PIT5665A Poor Remote Keyless Entry (RKE) Fob or Passive Unlocking Range

Models

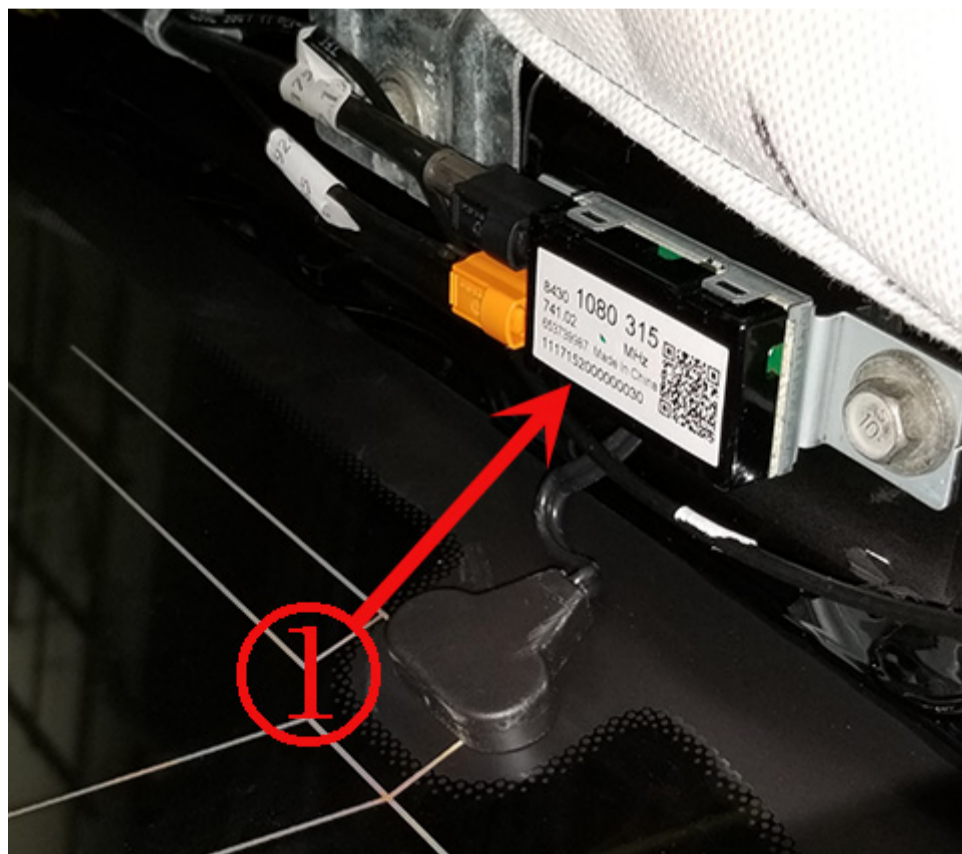
Involved Region or Country	North America
Condition	Some customers may comment on poor remote keyless entry (RKE) range (less than 20 feet.) Some customers may comment that the RKE fob must be held next to the driver's door handle before the doors will unlock when passively attempting to unlock the door.
Cause	Engineering is currently investigating this concern.

Replacing the Radio Antenna Amplifier (1) may correct the range concern.
